# LHAM2

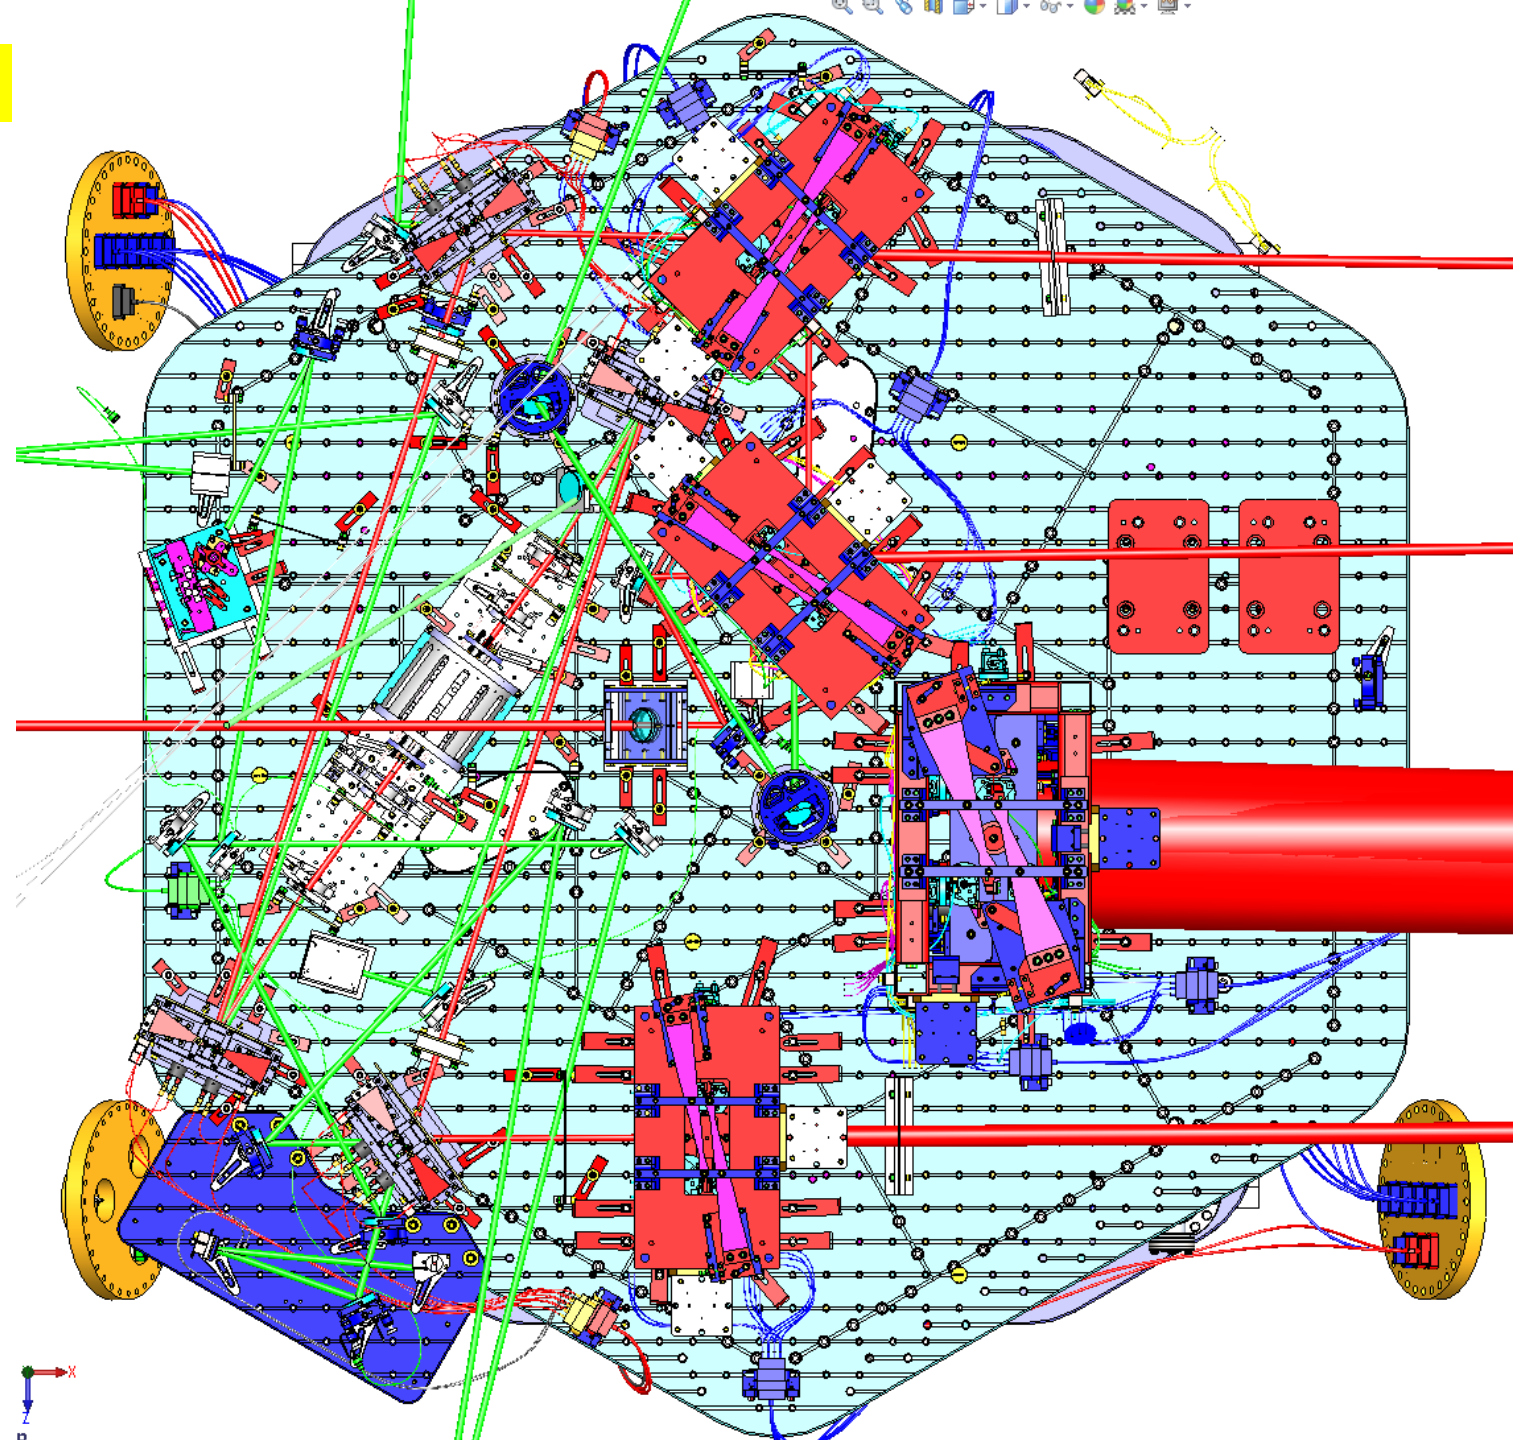
Optic orientation & location was fixed, one issue is it will need a long fork for clamping, and there is a collision with HAM AUX Cables Harness.

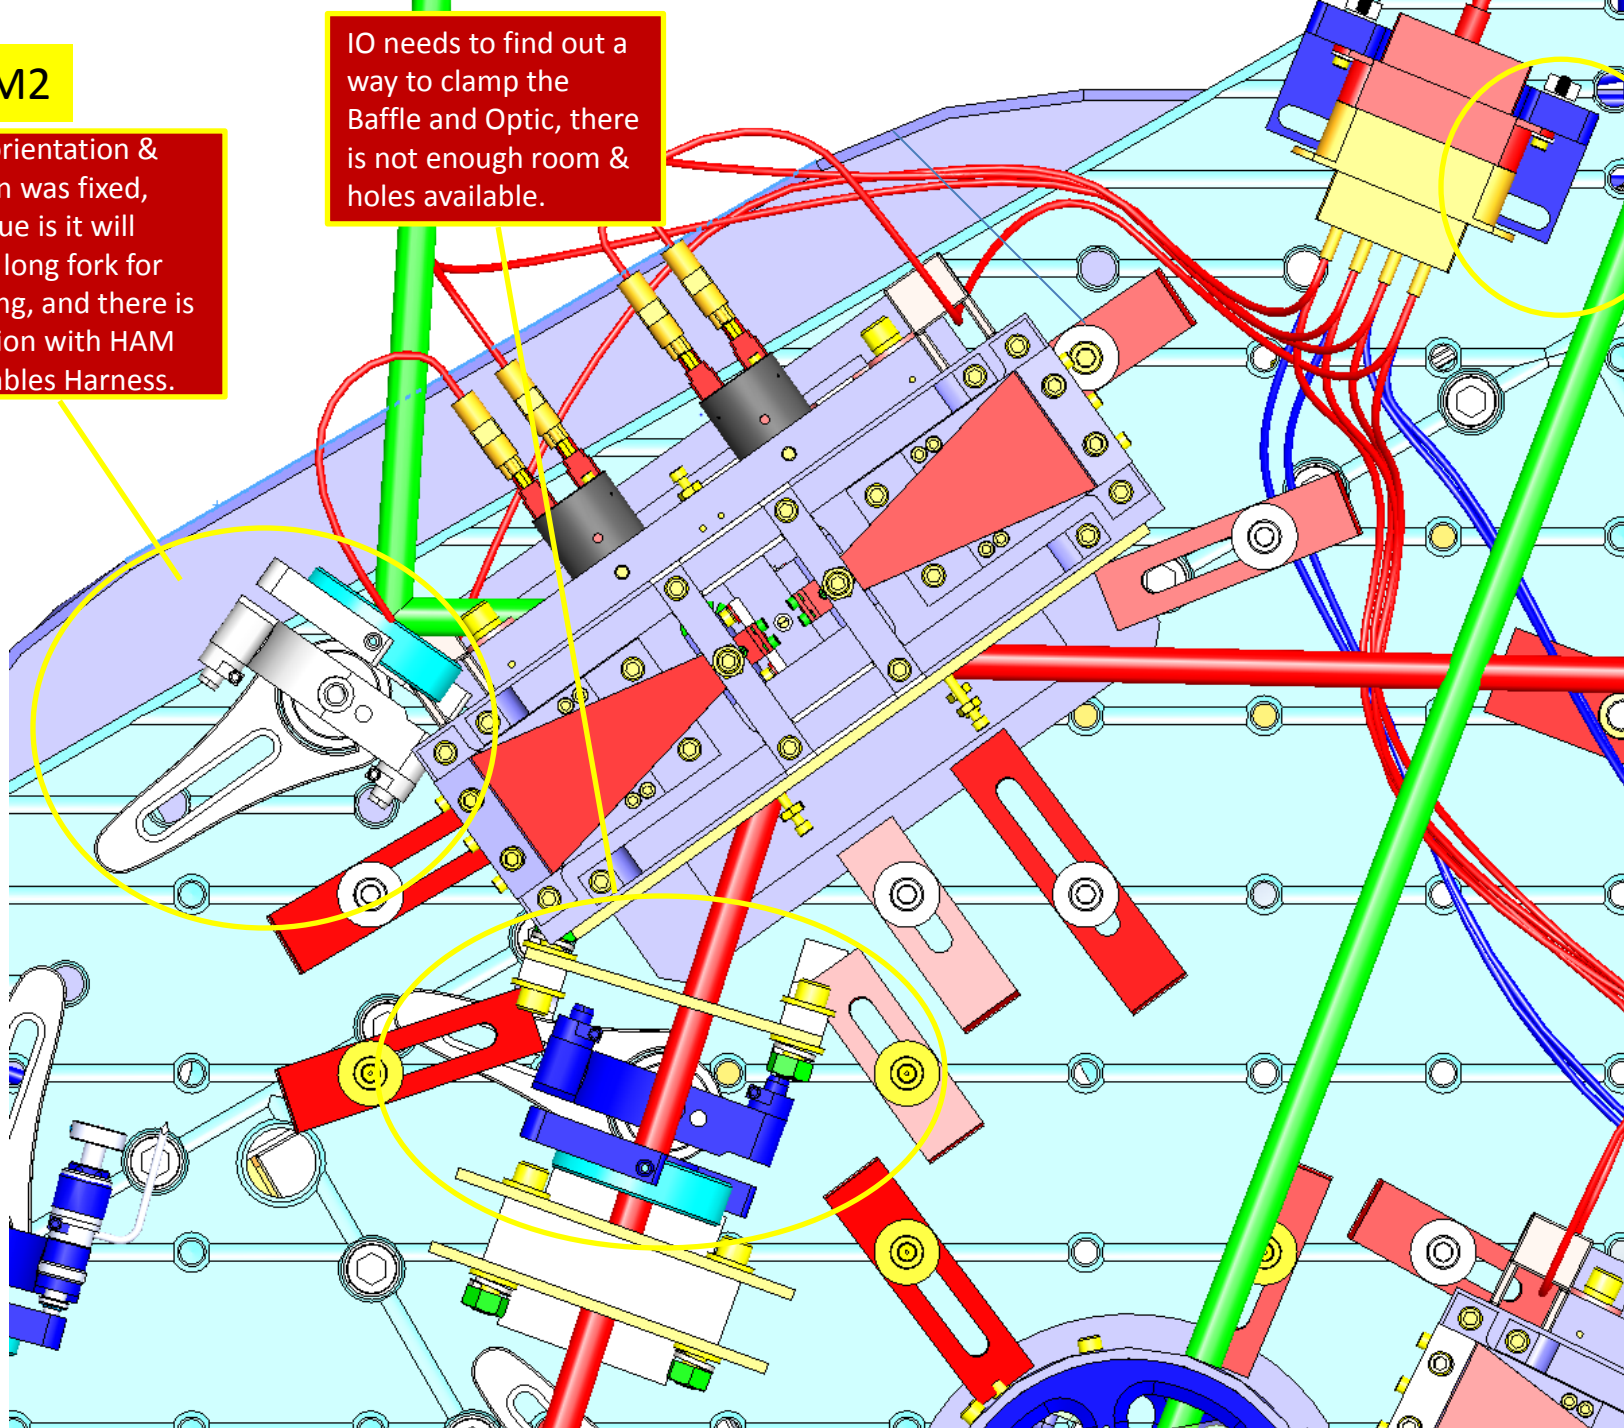
IO needs to find out a way to clamp the Baffle and Optic, there is not enough room & holes available.

Not sure if location of this Optic is correct.

IO needs to fix location of Dog clamps in FI.

LHAM2

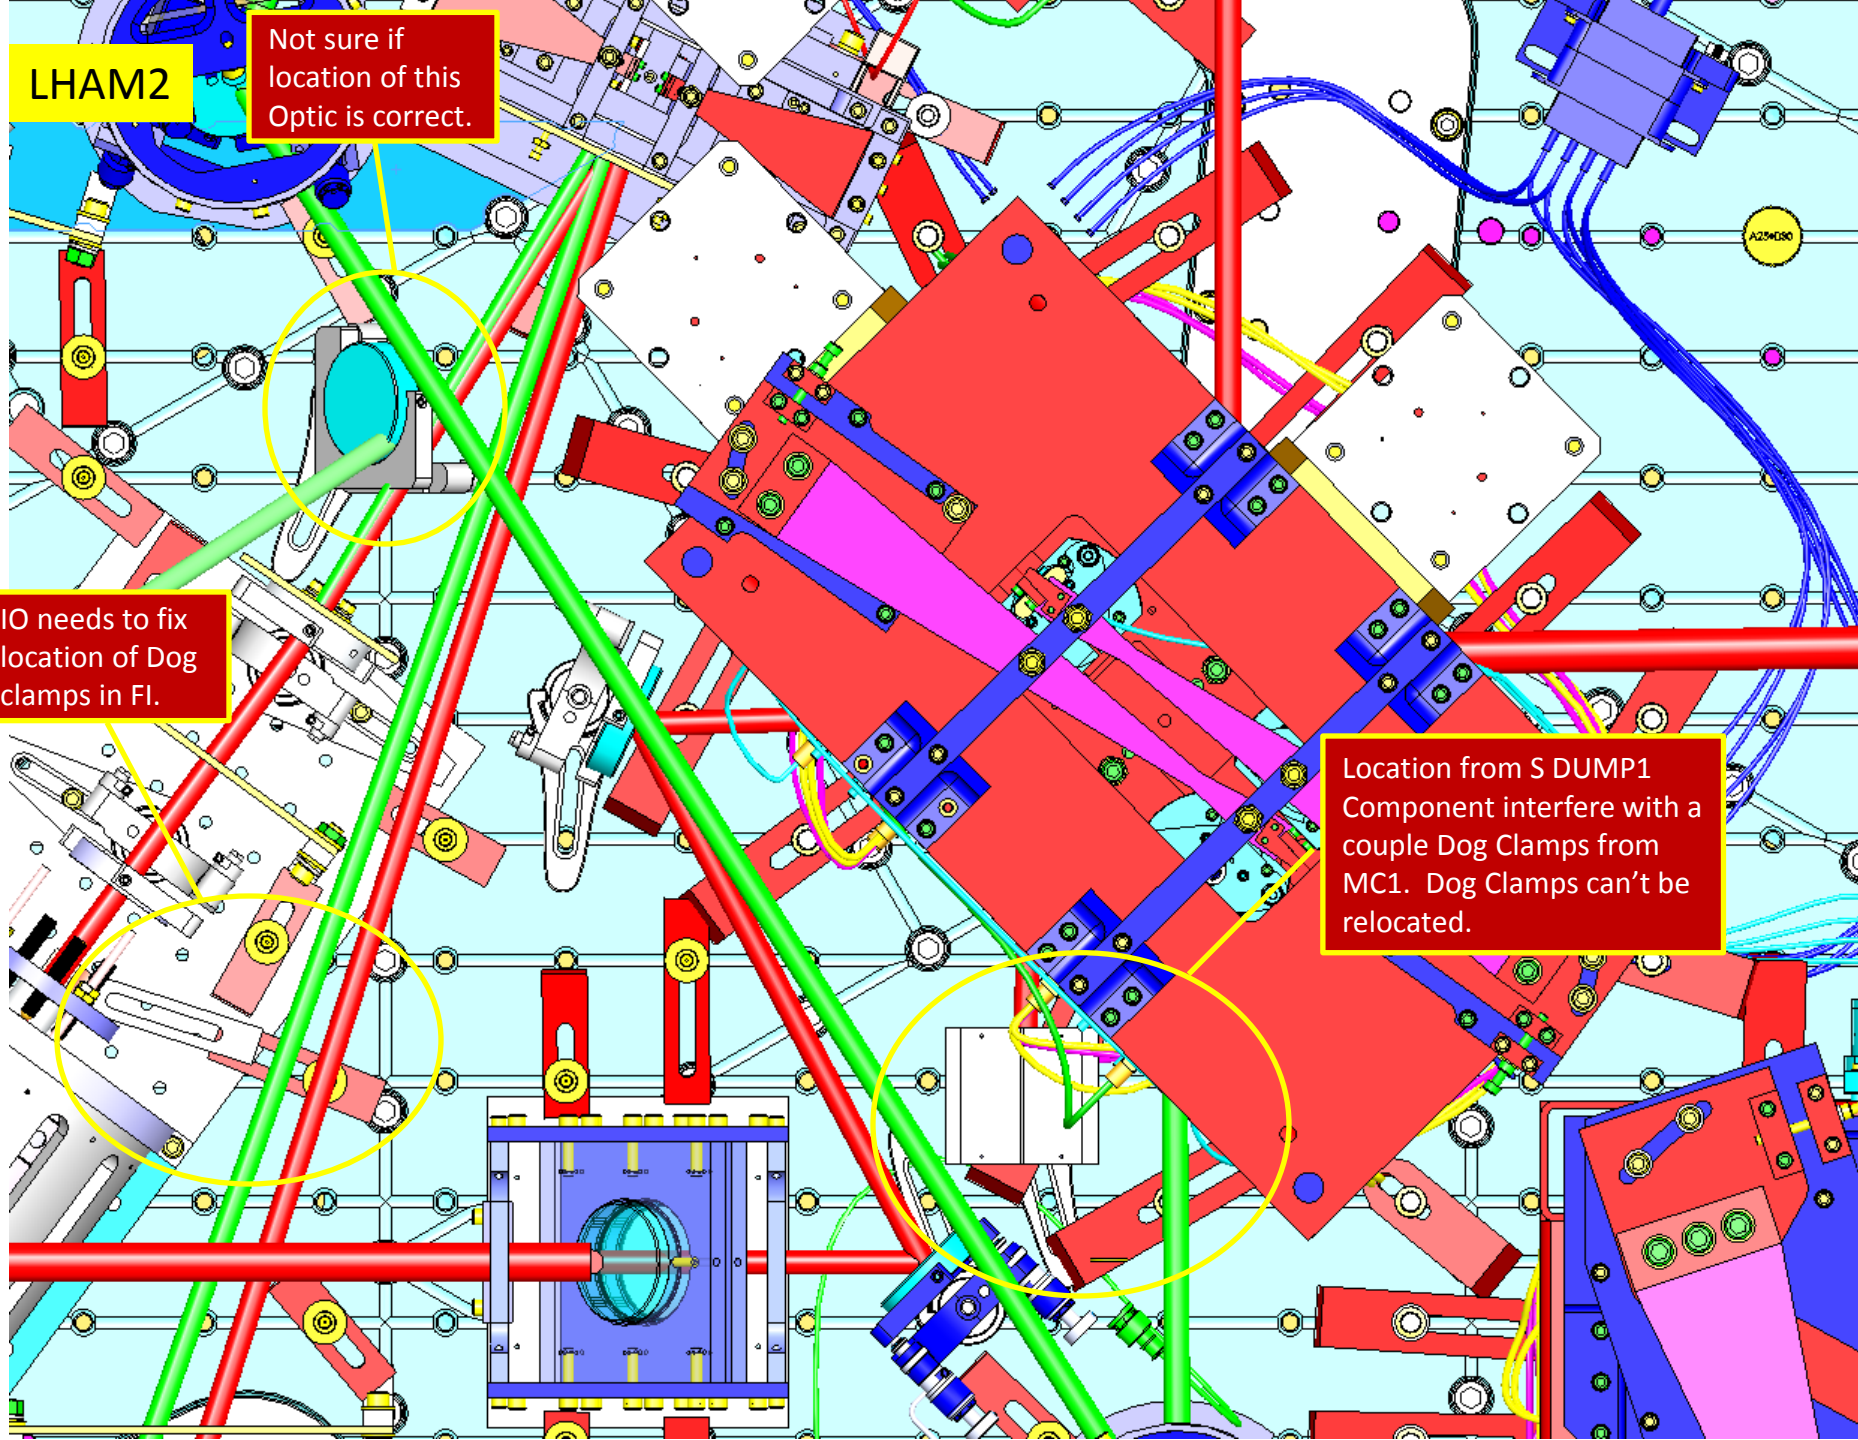
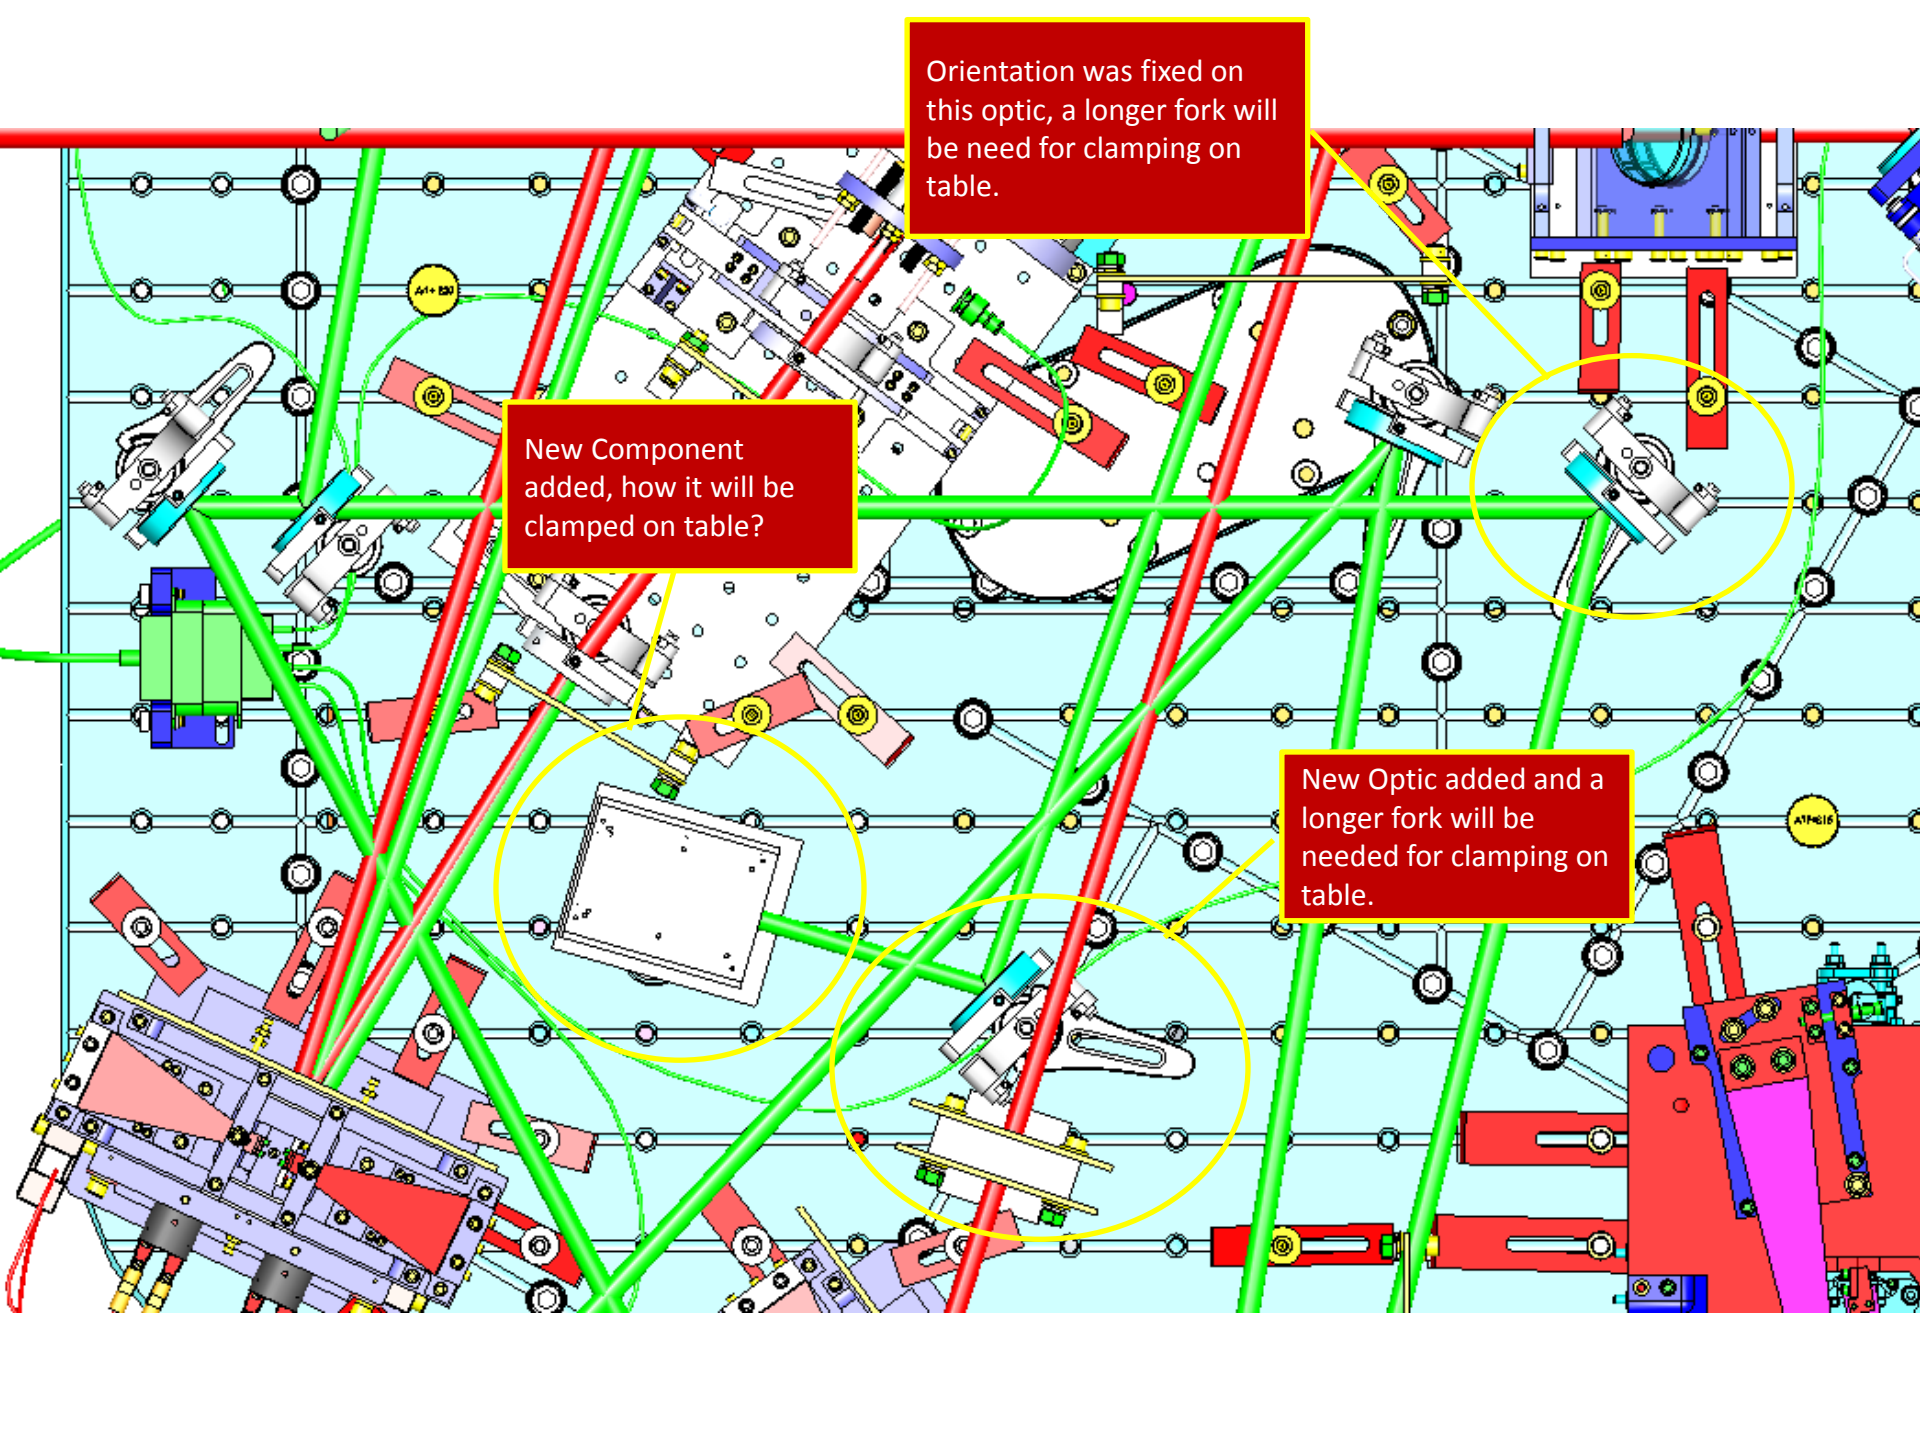
Location from S DUMP1 Component interfere with a couple Dog Clamps from MC1. Dog Clamps can't be relocated.

Orientation was fixed on this optic, a longer fork will be need for clamping on table.

New Component added, how it will be clamped on table?

New Optic added and a longer fork will be needed for clamping on table.

IO will re-design this baffle
